Port Gamble S'Klallam Tribe Heronswood Garden Water Main Extension

Project Number: 10182300030

Addendum No. 1

February 19, 2024

Figure 7-1: Standard Detail - Standard Trench and Pavement Restoration

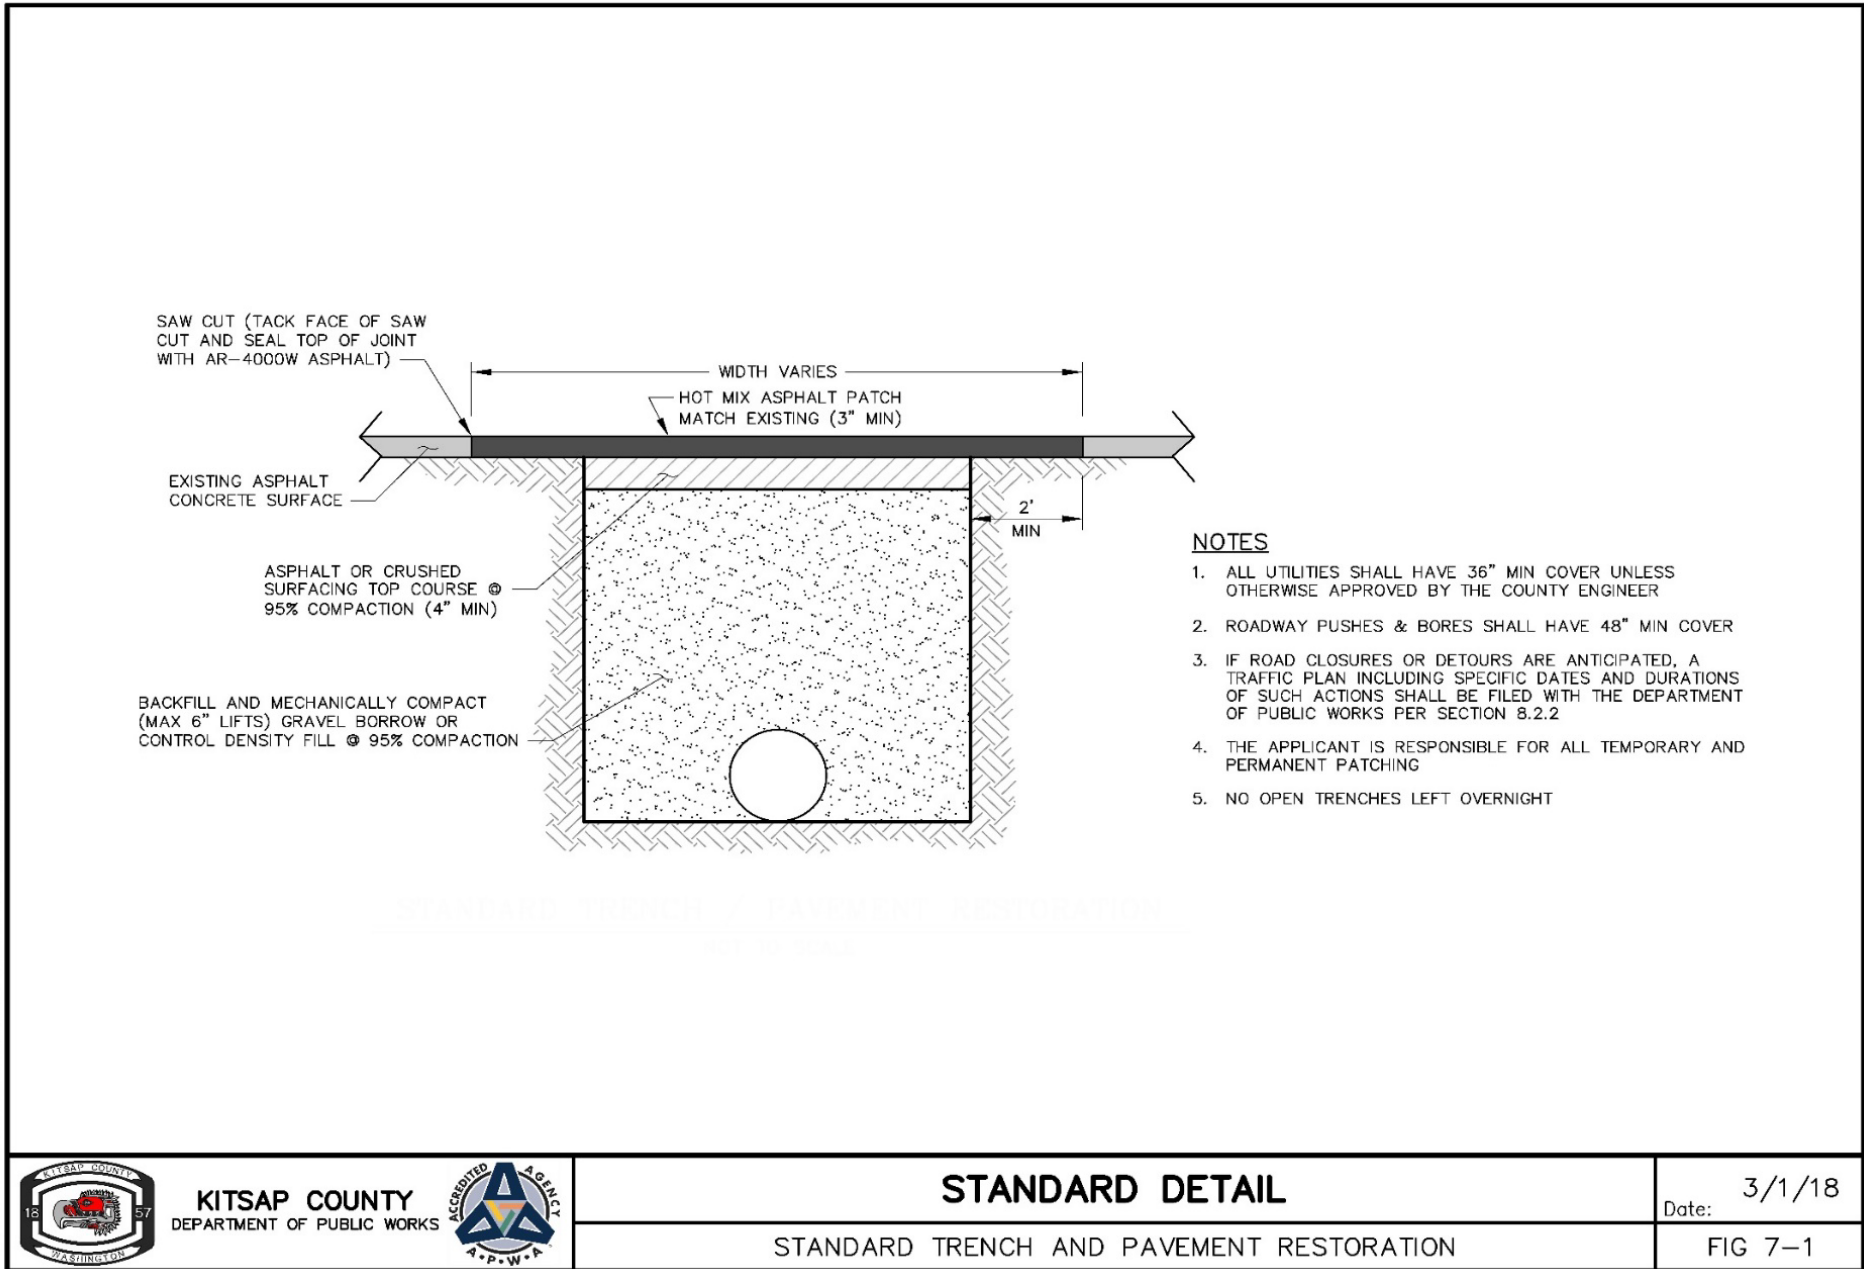
Sheet 15 of 20 Water Details & Notes

Add the attached Fig 7-1 Standard Trench and Pavement Restoration

Surface restoration and backfill required at roadway crossings with gravel borrow, crushed surfacing top course, or CDF meeting the requirements of WSDOT Standard Specifications and mechanically compacted to 95 percent of maximum density (modified proctor) in accordance with WSDOT Standard Specifications. Including export and disposal of unsuitable materials.

Requirements for utility trenching will be per Kitsap County Road Standards Section 7.5.3.2.

Paving for all pipe restoration areas crossing Hansville Rd and 288th Rd NE shall be a minimum of 3-inch compacted depth of HMA, 2-inch compacted depth of CSTC, and 6-inch compacted depth of CSBC. Pavement shall be done per **Kitsap County Road Standard Section 3.6.**
